2029 24TH AVE S
Full Design Review - Recommendation Meeting
#3025443-LU 05.23.2024

EDG: BOARD COMMENTS AND RESPONSE

FULL REC: EAST ELEVATION

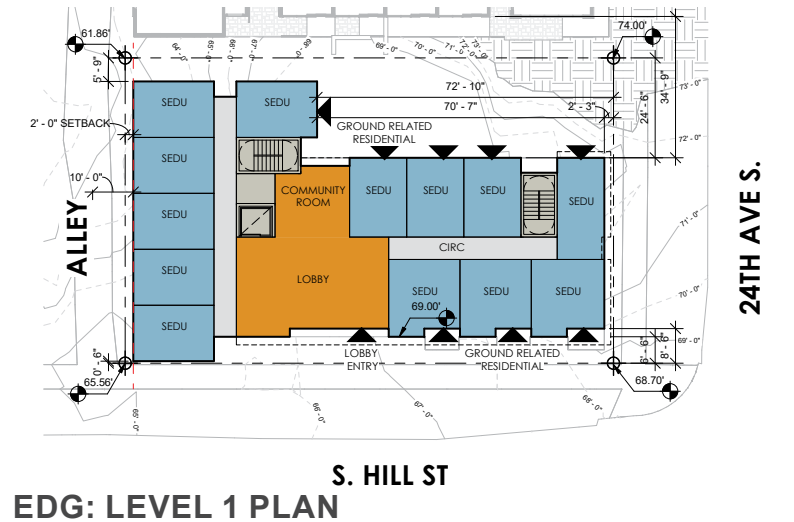
B The Board supported the applicant's material palette that included brick, fiber-cement and wood composite materials and felt that it complimented the adjacent building to the north. (CS2-D, CS3-A)

The monochromatic material palette has been maintained through the brick and fiber cement materials. Instead of wood composite materials, architectural concrete and white metal sunscreens have been proposed. The palette refinement still compliments the project to the north while also distinguishing it. (05/23/2024)

FULL REC: LOBBY PLAN

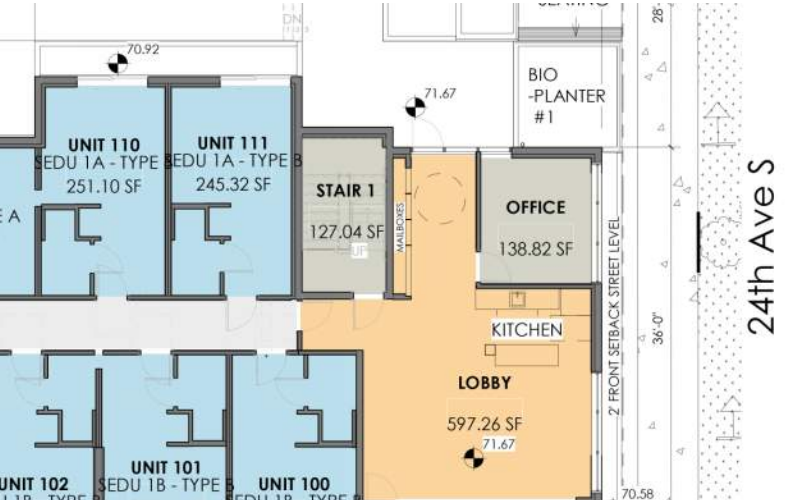
A The Board felt a portion of the community room should include kitchen facilities to create a space to foster interaction between the residents of the building. (PL3-B)

B The Board requested the applicant look at providing other activity space within the lobby to promote interaction with the courtyard on the north side of the building. The Board reiterated that providing activity space on the ground floor next to the courtyard would assist in fostering interaction between residents of the building. (DC3-B)

A common kitchen has been kept in the lobby area as an amenity to the residents. (05/23/2024)

We are providing more activity within the lobby space by adding the mail area, an office, and the common kitchen. These activities connect to the northern courtyard where there are more opportunities for engagement. There are tiered levels with a lawn area and it connects to the building to the north. (05/23/2024)

FULL REC: FENCING/GATES OFF 24TH AVE

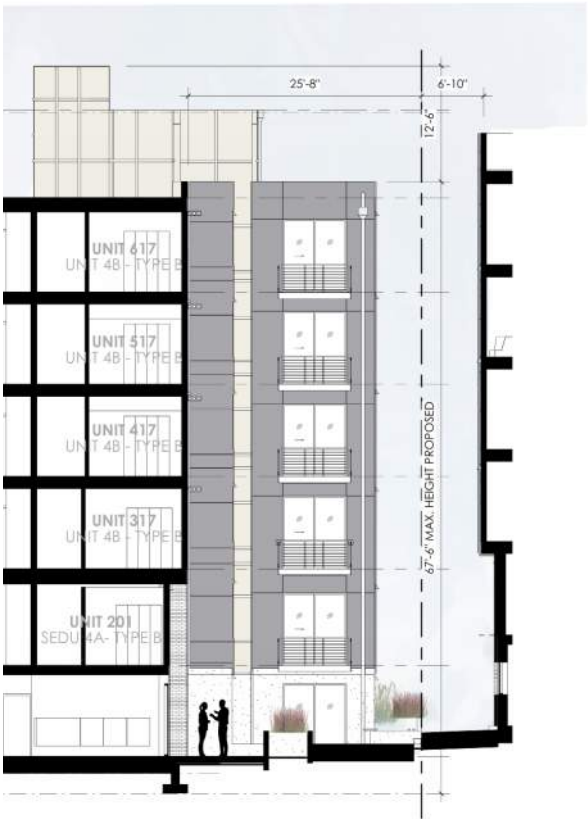
A The Board requested additional details for the Recommendation phase showing the how residents would access the courtyard, from inside the building and along 24th Avenue and the alley. The Board acknowledged that some form of fencing for security was appropriate, however, the design of the fencing should be porous to allow those within the courtyard and pedestrians along the street or alley to see in the courtyard area. (PL2-B)

The courtyard will be accessed through controlled access points. Gates along the alley and 24th Ave S will restrict public access into the interior space. The fence will be high quality metal material. The fence will be porous to allow pedestrians along 24th Ave to have visual access into the courtyard space. (04/08/2017 and 05/23/2024)

EAST ELEVATION - VIEW OF SITE FROM 24TH AVE S.

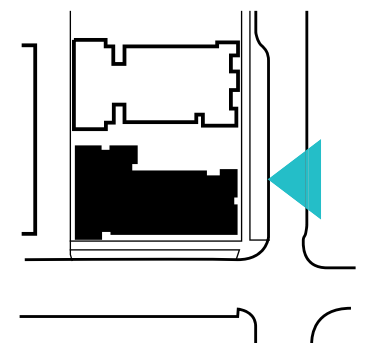
C The Board had concerns about the lack of glazing and visual interest on the east facing façade shown for floors 2-4. The Board again felt that increased glazing, added architectural elements or possibly reorienting the upper level units should be included to these upper floors for this façade to create visual interest and compliment the building to the immediate north (MUP #3020618). (DC2-B)

2C. Increased glazing on upper floors

2A. Lobby and Amenity Space moved to street corner

4A. Visual connection to Courtyard from 24TH AVE

DEPARTURE REQUEST - UNITS 100 + 101

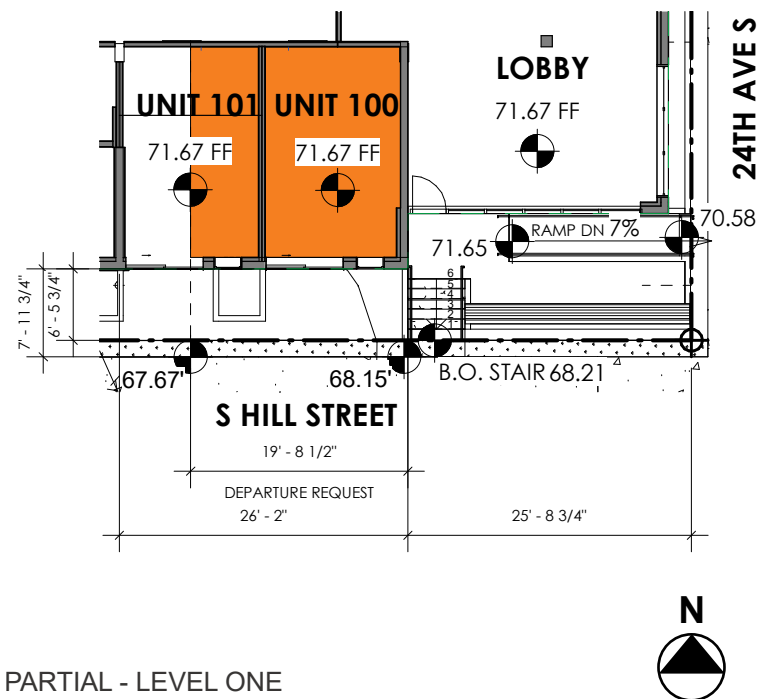
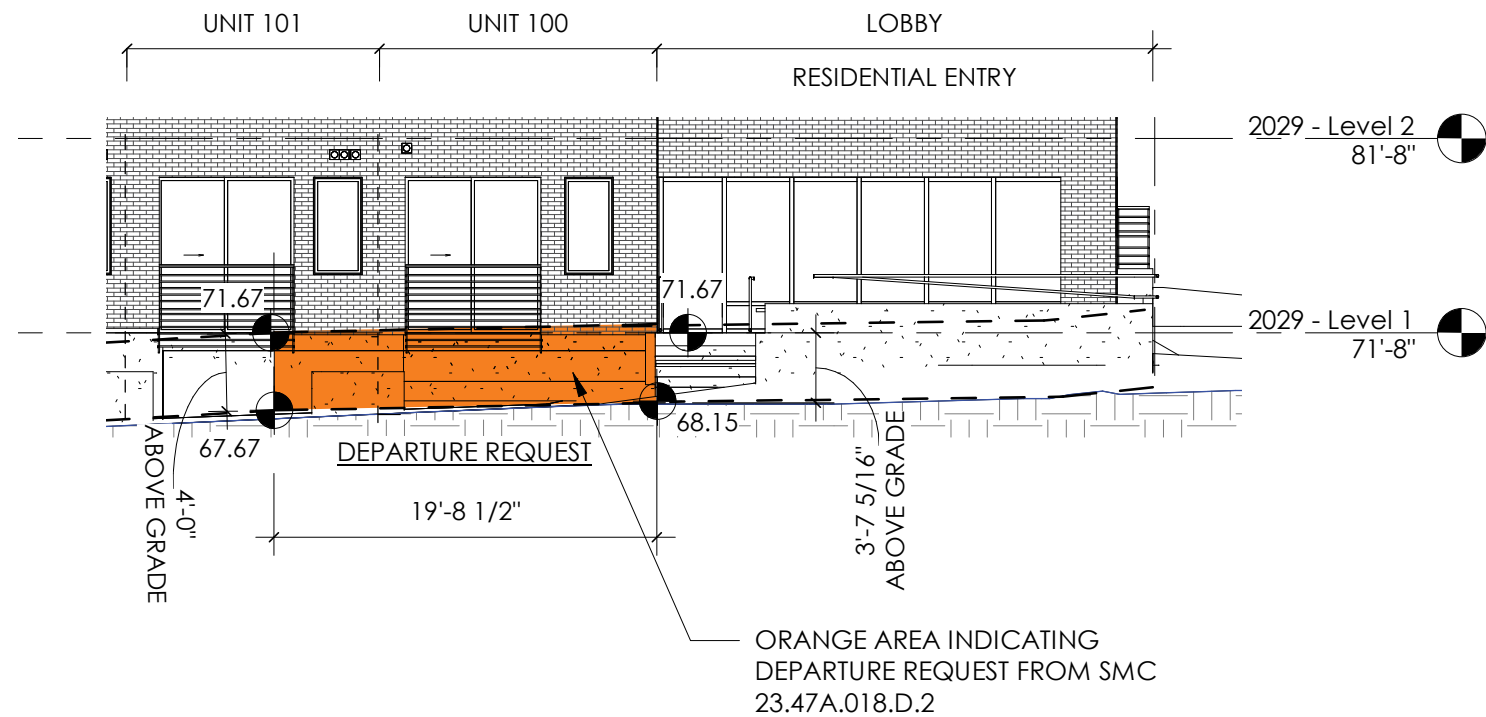
Departure Request for Units 100 and 101 to be less than 4' above finish grade, and to be set back less than 10' from the property line facing S Hill Street. These units are set back 7' 11 3/4" from the sidewalk and they are 3.76' average above the finish grade.

Units 101 and 100 meet the majority of both requirements, when only one needs to be met. See percentages below.

By proposing the majority of these requirements, we believe we meet the intent of the code for the residential units to have privacy from the street. There is also a landscaping buffer provided between sidewalk and unit facade.
